Project	IEEE 802.16 Broadband Wireless Access Working Group < http://ieee802.org/16 >
Title	Combined figures 500 and 501
Date Submitted	2006-09-12
Source(s)	Peretz Feder - Lucent Technologies [mailto: pfeder@lucent.com]
Re:	
Abstract	This contribution proposes operator ID bit mapping
Purpose	Adoption
Notice	This document has been prepared to assist IEEE 802.16. It is offered as a basis for discussion and is not binding on the contributing individual(s) or organization(s). The material in this document is subject to change in form and content after further study. The contributor(s) reserve(s) the right to add, amend or withdraw material contained herein.
Release	The contributor grants a free, irrevocable license to the IEEE to incorporate material contained in this contribution, and any modifications thereof, in the creation of an IEEE Standards publication; to copyright in the IEEE's name any IEEE Standards publication even though it may include portions of this contribution; and at the IEEE's sole discretion to permit others to reproduce in whole or in part the resulting IEEE Standards publication. The contributor also acknowledges and accepts that this contribution may be made pu

Figure 500 – Registration Primitives (MS and BS)

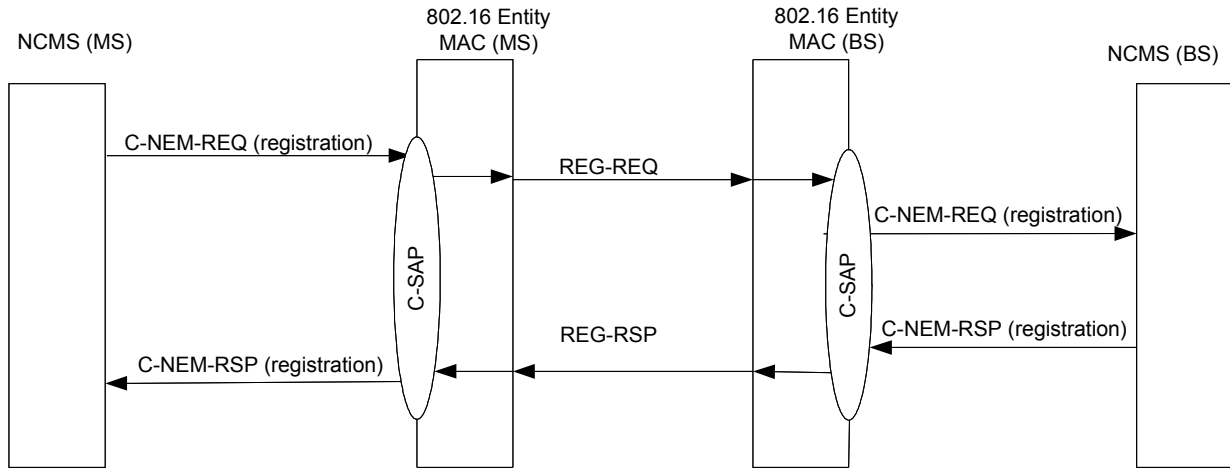
Present end-to-end view of Figures 500 and 501, REG-REQ and REG-RSP

Produce a format that shows end-to-end exchange of REG-REQ and REG-RSP between MS+NCMS and BS+NCMS

In section 14.2.8, combine Figures 500 and 501 per below:
